**COLERAIN TOWNSHIP ZONING COMMISSION**

NAME OF PROJECT: S & T Auto Detailing

**RE: Case #ZA2016-07 – 3330 Compton Road**

**STAFF REPORT:** Final Development Plan  
Case #ZA 2016-07  
3330 Compton Road  
S&T Auto Detailing  
October 18, 2016

Sheet:  
L100

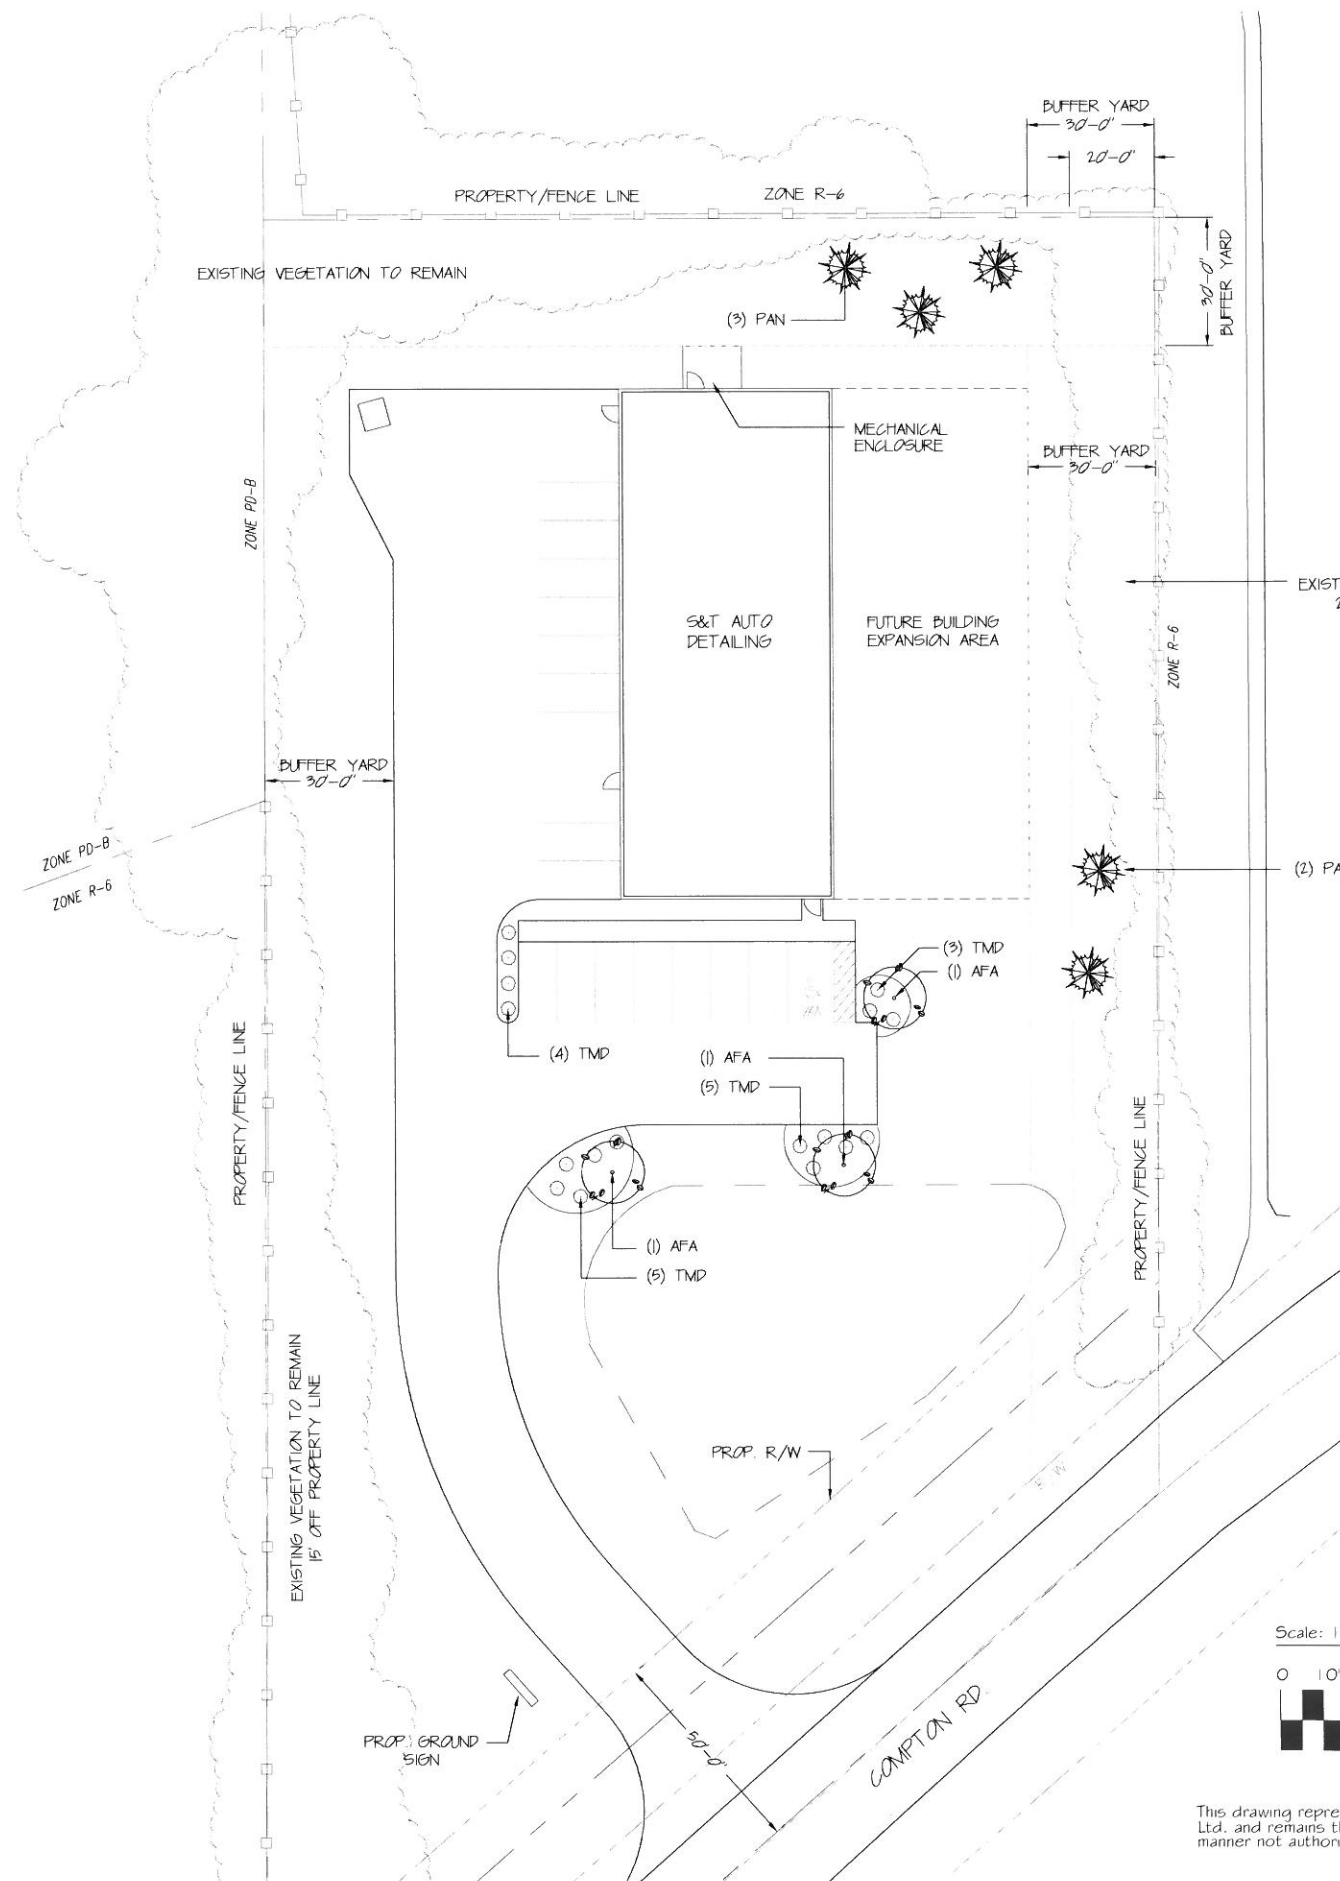
5. **Section 14.4.4 (B) Landscaping Materials** requires that Shrubs and Hedges must be at least 36 inches in height at the time of planting. The landscape plan indicates that the 17 proposed Dense Yew plantings will 24 inches at the time of planting.

6. **Section 14.4.4 (C) Species Diversity** requires that when fewer than 40 shrubs are required on a site, at least 2 different species shall be utilized, in roughly equal proportions. The landscape plan indicates that all shrubs required on the site will be of the same species.

7. **Section 14.6.1 Minimum Landscaping Requirement for Parking Areas** requires that a minimum of 15 percent of the parking area shall be landscaped. For the 11,060 SF parking area 1,659 SF of landscaping is required. The landscape plan indicates that 1,050 SF of landscaping is included in the proposed Final Development Plan.

3. That the applicant meets the requirements of Section 14.4.4 Landscaping Materials including but not limited to the height of Shrubs and Hedges which must be at least 36 inches in height at the time of planting and the diversity of Shrubs.

4. That the applicant includes 609 SF of additional new landscaping to meet the requirement of Section 14.6.1 Minimum Landscaping Requirement for Parking Areas.

**SITE PHOTOMETRIC**  
SCALE: 1"=10'-0"

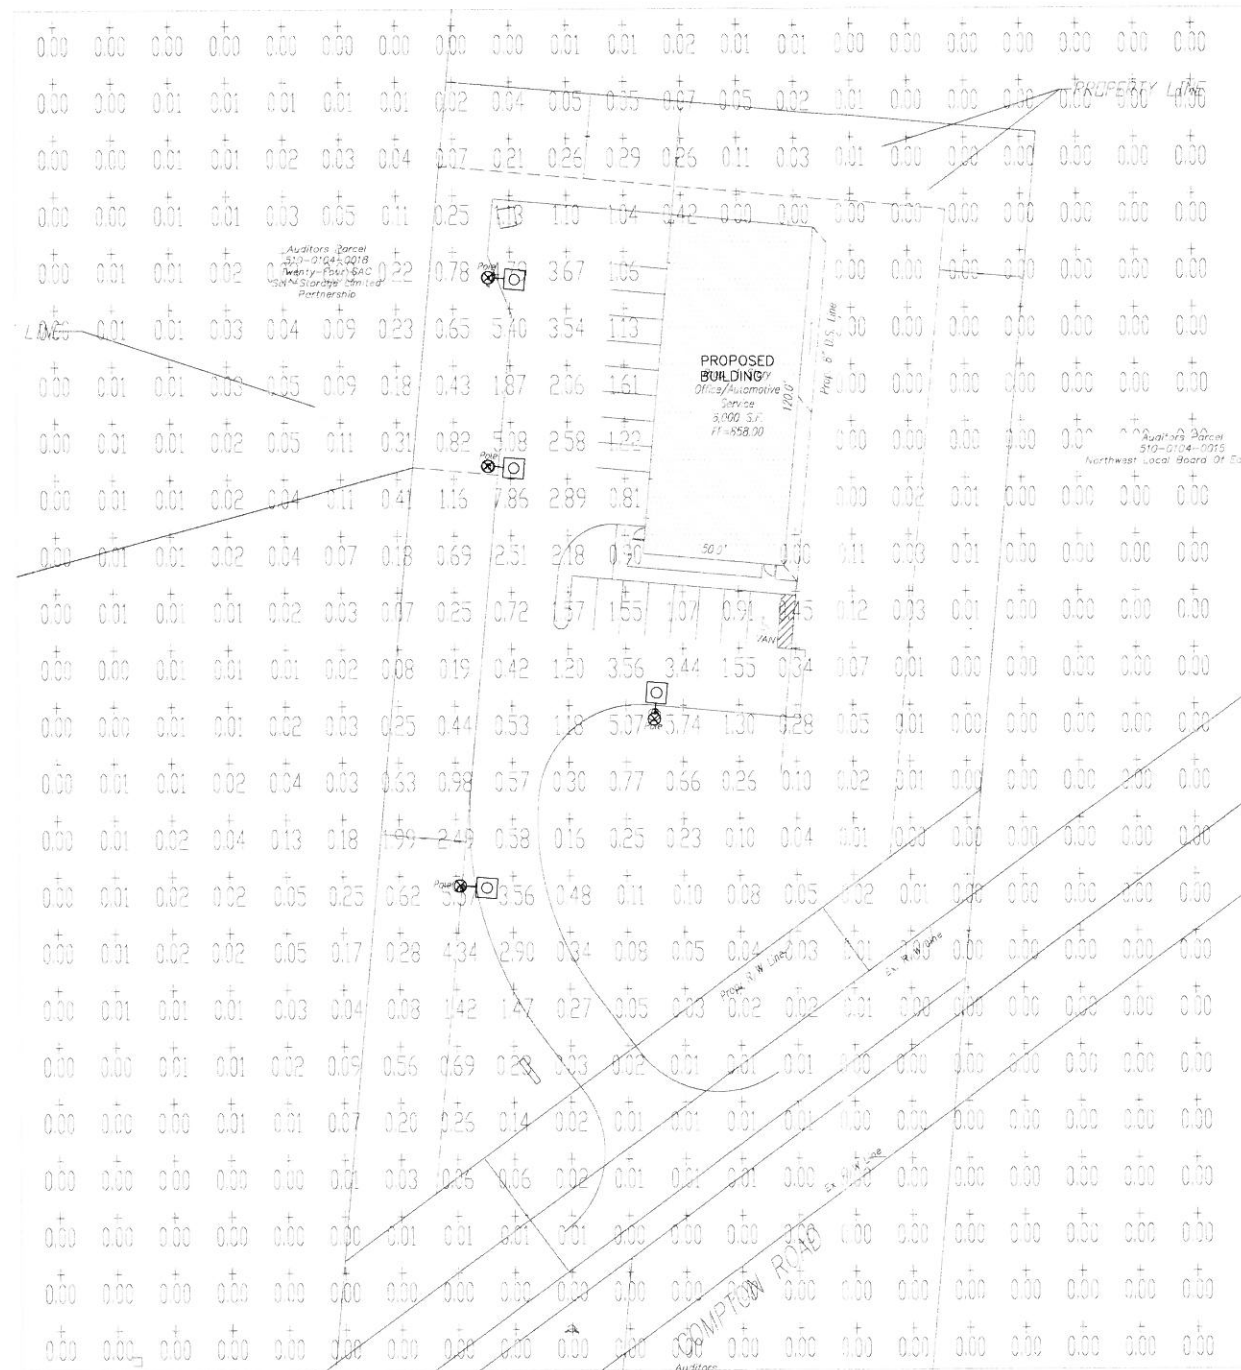
1. **Section 12.9 Outdoor Lighting** requires that maximum illumination at property lines for cutoff lighting should be no more than 0.50 for a PD-B district by restricted to 0.10 in cases where properties are immediately adjacent to residential zoning districts. The proposed Final Development Plan is immediately adjacent to a Cincinnati Bell Office facility to the west which is a non-conforming use currently zoned as residential. The site photometric plans indicate that some portions of the western property line are at or slightly exceeding the 0.50 maximum allowance. In one particular location near the most southern proposed lighting fixture (along the access driveway) the plan indicates an illumination of 1.99, which greatly exceeds the 0.50 maximum for a business use and the 0.10 neighboring a residential zone.

2. **Section 12.9 Outdoor Lighting** requires that the maximum illumination at of cutoff lighting be an average of 2.0 over parking lots. Staff calculates the average illumination across parking areas to be 2.217 footcandles based on the submitted site photometric plan.

1. That the applicant relocates the southernmost light fixture which is proposed for the western side of the driveway to the eastside of the driveway in order to alleviate the footcandle overage at the western property line.

1. That a variance be granted from Section 12.9 to allow for the average illumination of the parking area to be 2.2 on the basis that the site is well buffered with dense vegetation along the western portion of the property.
2. That a variance be granted from Section 13.4.2(C) Walkway Connections to Public Sidewalks to allow the applicant to forego a designated pedestrian walkway connection from the Right-of-Way to the proposed building if the applicant is granted approval for a waiver of the sidewalk requirement by the Board of Trustees.
